New Bias Circuit For Munin2 – Eliminates the Potentiometer for a 3.9 K Ohm Resistor

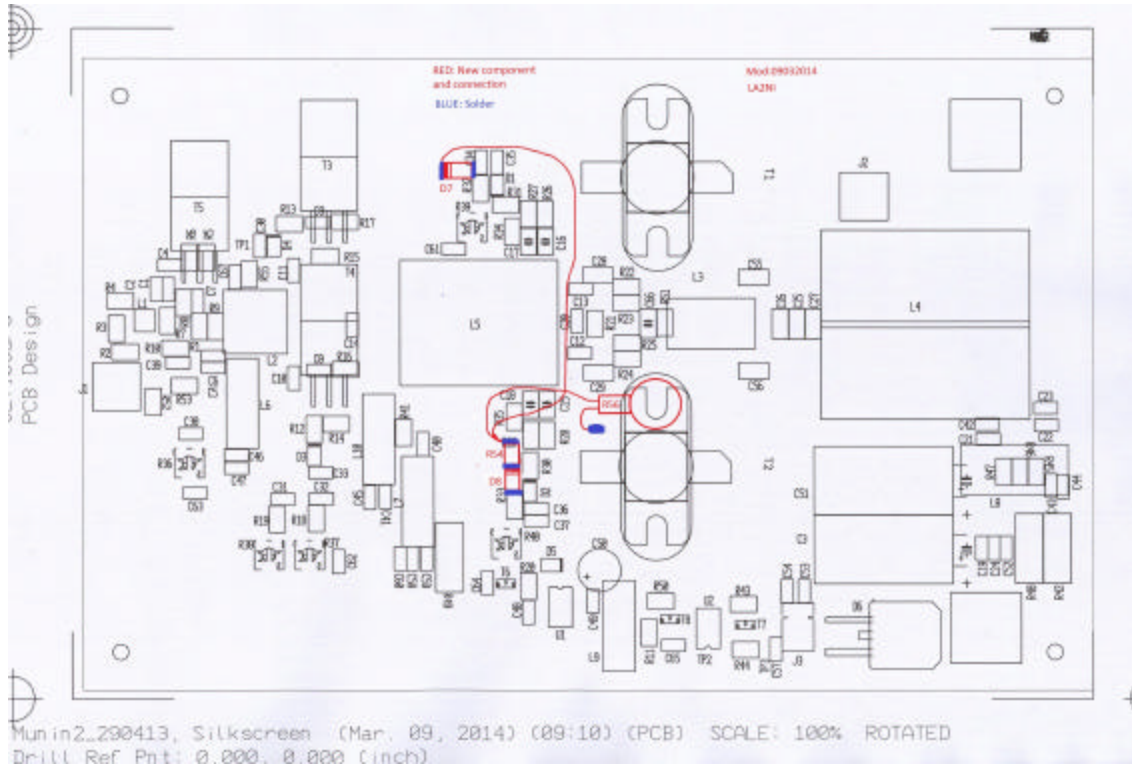
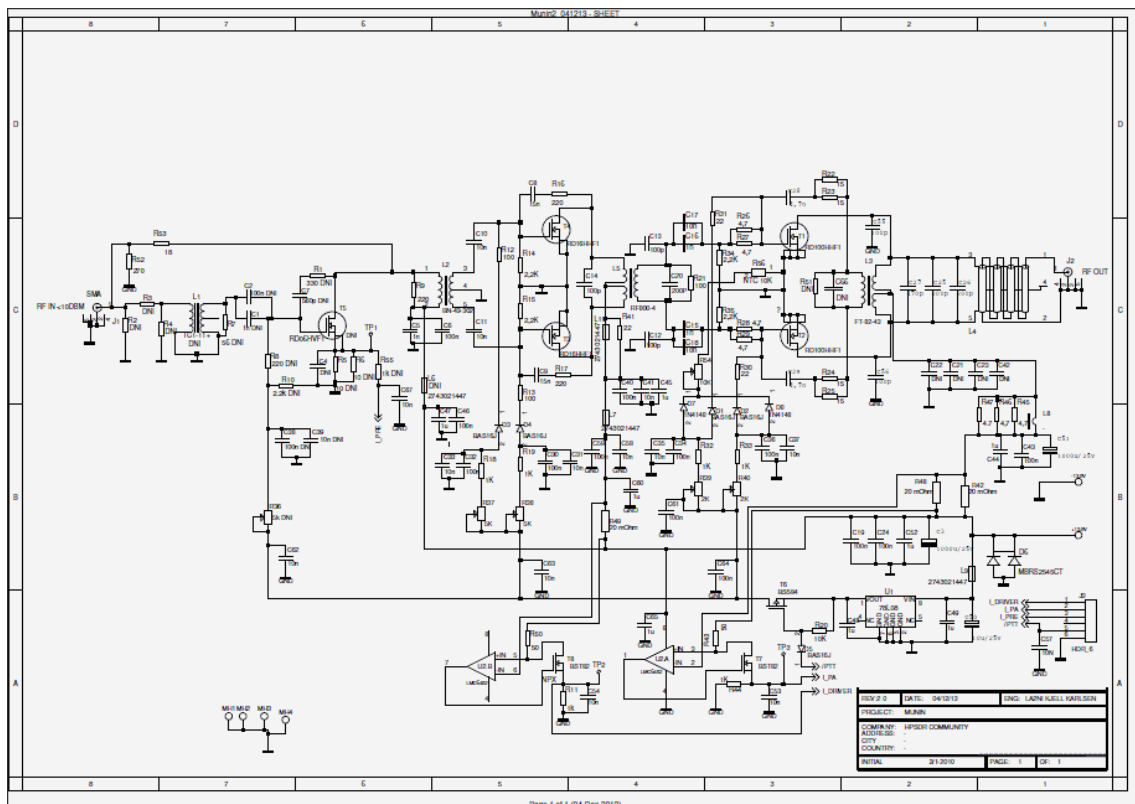
D7, D8 = BAS16J - Mouser #: 771-BAS16J115

R54 = 3.9 K Ohms SMD 0805

R56 = NTC 10K 2% P/N: NTCALUG02A 103G Attach Directly to T2 under ground strap
Mouser #: 594-NTCALUG02A103G
